Massachusetts Electric Company  
Nantucket Electric Company  
Each d/b/a National Grid  
D.P.U. 23-150  
Exhibit EDF-CLF-JRC-1  
March 29, 2024  
H. O. Tassone

Petition of Massachusetts Electric Company and )  
Nantucket Electric Company each d/b/a National Grid )  
Pursuant to G.L. c. 164, § 94 and 220 C.M.R. § 5.00 for ) D.P.U. 23-150  
Approval of an Increase in Base Distribution Rates and )  
Approval of a Performance-Based Ratemaking Plan )

PRE-FILED DIRECT TESTIMONY OF

ENVIRONMENTAL DEFENSE FUND  
AND  
CONSERVATION LAW FOUNDATION

**Figure 1: National Grid’s historical and proposed Core Investments<sup>57</sup>**

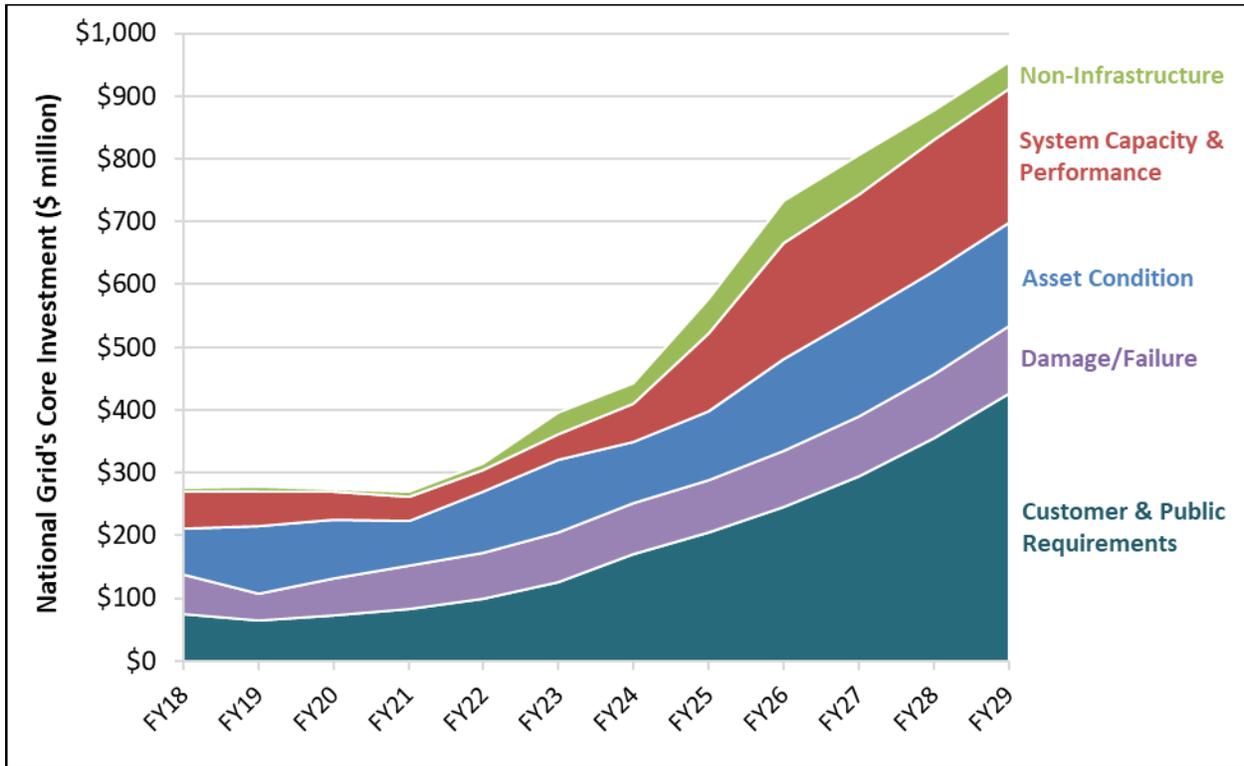
3 A. The Company estimates that it will need to invest approximately \$4 billion in Core  
4 Investments during the five-year CPIP period, which averages out to roughly \$790 million  
5 per year (see Figure 1).<sup>53</sup> National Grid itself notes that level of investment is  
6 unprecedented.<sup>54</sup> The Company expects its Core Investments to increase by 42 percent  
7 between the test year and the start date of its CPIP, from \$395 million in FY 2023 to \$577  
8 million in FY 2025.<sup>55</sup> During the five-year CPIP period, these Core Investments will  
9 continue to grow by 17 percent annually until reaching \$954 million in FY 2029.<sup>56</sup>

When comparing these cost forecasts to historical spending, the Company’s CPIP Panel asserts that “to maintain the same level of reliability to customers today, it will require unprecedented levels of capital spend to provide safe and reliable electric distribution service.”<sup>58</sup>

**Figure 2: Current Rate R-2 Energy Burden<sup>141</sup>**

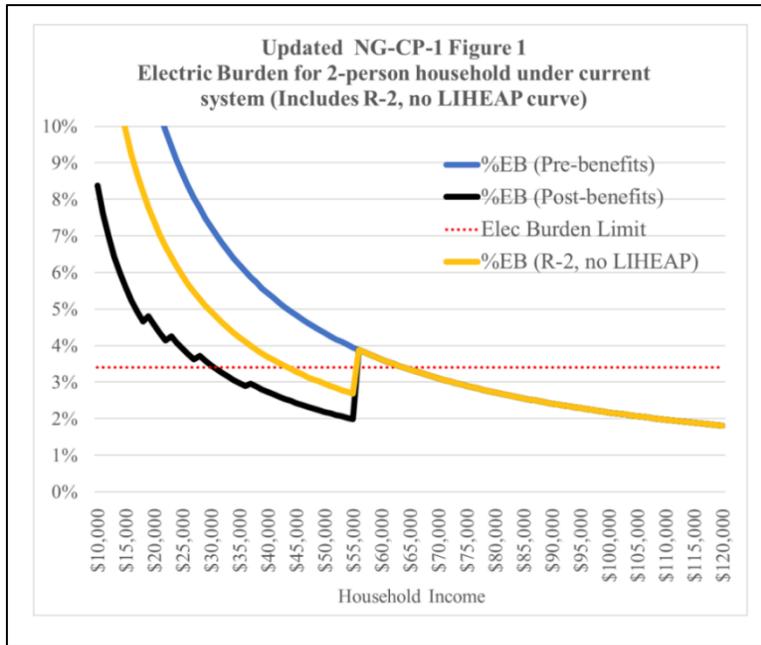
The figures show that National Grid’s customers are less energy insecure under National Grid’s revised proposal, but under both the current and proposed Rate R-2, the Company’s poorest customers do not achieve energy affordability without a LIHEAP distribution. Figure 3 shows that under National Grid’s revised Rate R-2 that customers in a 2-person household with household incomes below \$40,000 will not meet the 3.4 percent energy burden goal without a LIHEAP distribution.

14 A. I recommend that DPU require National Grid to reconfigure its proposed Rate R-2 in its  
15 rebuttal testimony such that all customers pay no more than 3.4 percent of their household  
16 income for electricity bills without an assumption of LIHEAP distribution. To do this, the  
17 Company should provide greater percentage discounts for customers at the lowest end of
